ADVISORY COMMITTEE
ON THE MEDICAL
USES OF ISOTOPES

SUBJECT: TRANSMITTAL OF THE ACMUI DOSE
RECONSTRUCTION SUBCOMMITTEE REPORT TO
NRC STAFF

SUBJECT: Report to ACMUI

ACMUI Dose Reconstruction Subcommittee (DRS)
Appendix B: Technical Report
15 April 2004

Effective half life and Reconstructed distance of bedside readings

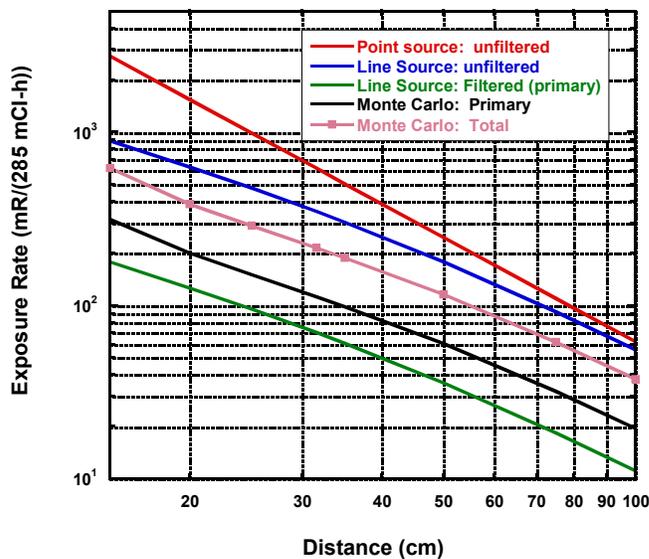
The more complete data consistently reveal $\lambda = 0.212 \text{ da}^{-1}$, equivalent to a half-life of 3.26 days. Based on Monte Carlo simulations, the patient-to-detector center distance best accounting for the measurements is about 20 cm. This suggests readings were taken with detector a few cm from lateral surface of the patient. Monte Carlo simulation is warranted in this particular case because the patient was known to have impaired renal function and because the fraction of thyroid uptake is typically small in metastatic thyroid cancer patients. This assumptions warrants treating the patient as a cylindrical volume source in which radioactivity is uniformly distributed.

Since a typical hospital bed is about 37 inches wide, the mattress edge-to-patient center is about 47 cm. Assuming that the daughter placed her forearms on the lateral aspect of the mattress edge, a distance of 37 cm would seem to be the shortest distance between the daughter's forearms and the patient center that could be maintained for a long period of time. Hence, DRS suggests that 37 cm is a more appropriate distance to apply to the Region III scenario rather than the estimated 20 cm measurement distance. Based on the ratio of MC air-kerma rates at 35 cm and 20 cm, it is reasonable to scale the beside readings downward by a 0.65 factor.
